# UNITED STATES PATENT AND TRADEMARK OFFICE

APPLICATION NO.	FILING DATE	FIRST NAMED INVENTOR	ATTORNEY DOCKET NO.	CONFIRMATION NO.
10/814,329	04/01/2004	Naoki Yoshida	P21-169535M/ISI	5337
21254	7590	07/16/2007	EXAMINER	
MCGINN INTELLECTUAL PROPERTY LAW GROUP, PLLC			HEWITT, JAMES M	
8321 OLD COURTHOUSE ROAD			ART UNIT	
SUITE 200			PAPER NUMBER	
VIENNA, VA 22182-3817			3679	
			MAIL DATE	DELIVERY MODE
			07/16/2007	PAPER

## Office Action Summary

**DETAILED ACTION*****Specification***

特開2003-21287

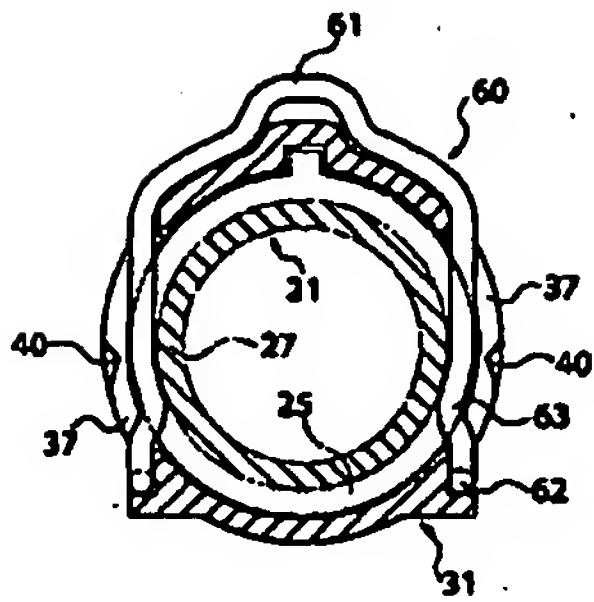
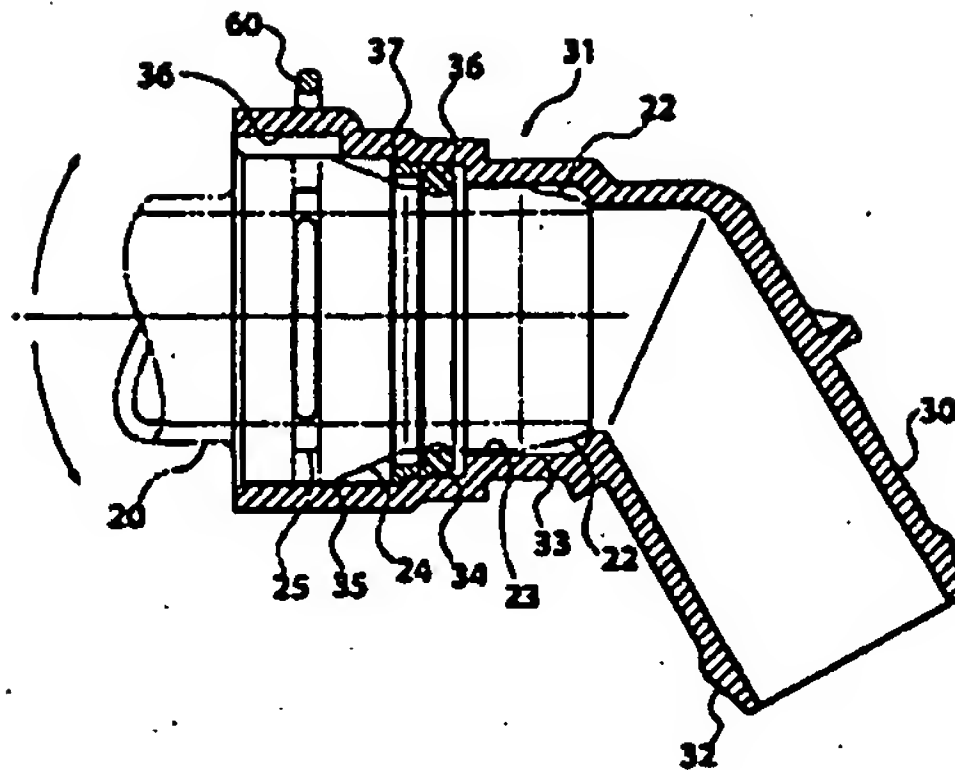
With respect to claim 20 and with particular reference to Figures 1-7 and Attachment A, Yoshida discloses a piping connector for connecting a first pipe to a second pipe, said piping connector comprising: a socket (Figure 2); a plug (Figures 1); and a hold ring (Attachment A) fixedly attached to an inner periphery of the socket, wherein said hold ring includes a groove at an outer periphery of the holding ring.

With respect to claim 3, wherein the inner periphery of the socket is provided with a first diameter contracted portion and a second diameter contracted portion from a side of an inserting port of the plug, and a stepped portion is formed between the first diameter contracted portion and the second diameter contracted portion. Refer to Figure 7 and Attachment A for various stepped portions between various diameter portions.

With respect to claim 6, wherein the inner periphery of the socket comprises: a first diameter contracted portion; a second diameter contracted portion; and a stepped portion formed between the first diameter contracted portion and the second diameter contracted portion. Refer to Attachment A.

With respect to claim 7, wherein said groove comprises a V-shape. Refer to Attachment A.

With respect to claim 8, wherein said hold ring comprises: a large diameter portion and a small diameter portion adjacent to the small diameter portion. Refer to Attachment A.

With respect to claim 9, wherein said groove is formed between said large diameter portion and said small diameter portion. Refer to Attachment A.

With respect to claim 10, wherein said groove is formed at an outer periphery of said large diameter portion, and said small diameter portion is formed at an end of said groove. Refer to Attachment A.

With respect to claim 11, wherein said groove comprises a wall portion having a tapered shape. Refer to Attachment A.

With respect to claim 12, wherein said groove comprises a wall portion having a tapered shape extending from a bottom portion of said groove to said small diameter portion. Refer to Attachment A.

With respect to claim 14, wherein said large diameter portion comprises an outer diameter substantially matched to an inner periphery of an inner portion of said socket. Refer to Attachment A and Figure 7.

With respect to claim 15, wherein said small diameter portion comprises an outer diameter substantially matched to an inner periphery of an inner portion of said socket. Refer to Attachment A and Figure 7.

Applicant's arguments, see pages 12-13, filed 4/30/07, with respect to claims 1, 3, 6-12 and 14-21 have been fully considered but they are not persuasive. Refer to the above reading of Yoshida and Atwood, and particularly Attachment A.
